CITY OF PORTLAND BUILDING PERMIT

Job ID: 2011-12-2836-ALTCOMM/2012-41693 AMEND

Portland Pottery #2
Proposed Layout
Amendment to Rear Exit Permit

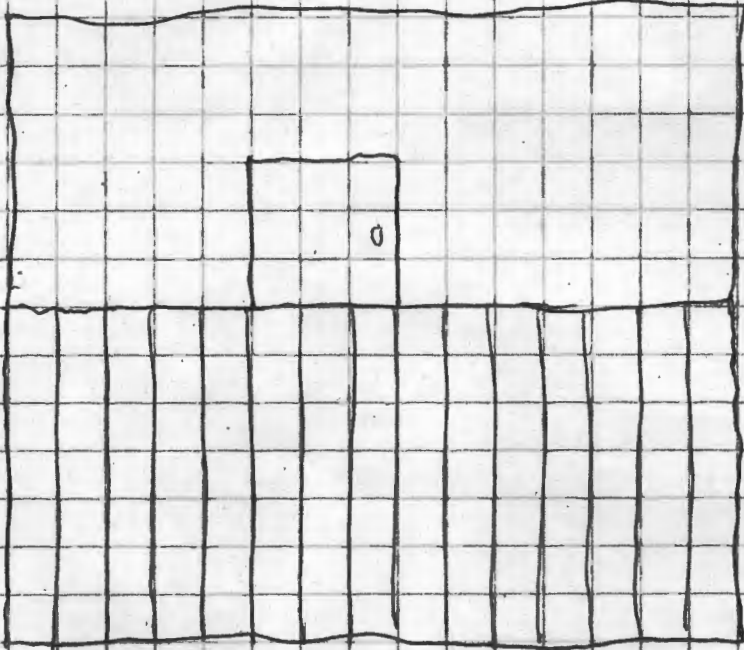
5/3/12
Per Lisa B.
2-2x10 Beam

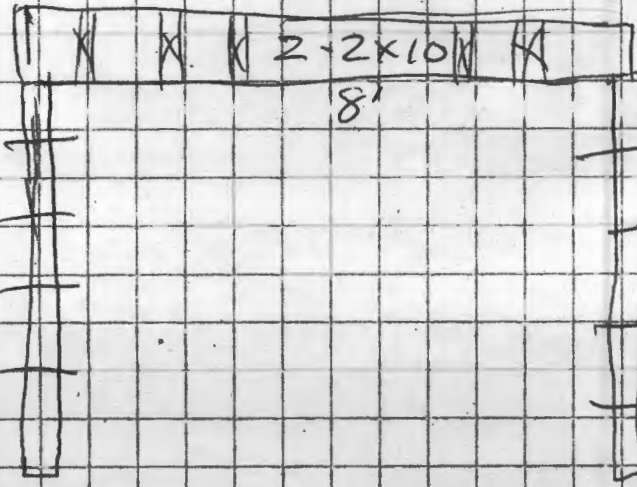
8x8' PT Deck
FRAMED w/ 2x10 PT
DECKING w/ 2x4 PT
16" O.C.

JOIST HANGERS
LAGGED INTO BLOCK WALLS
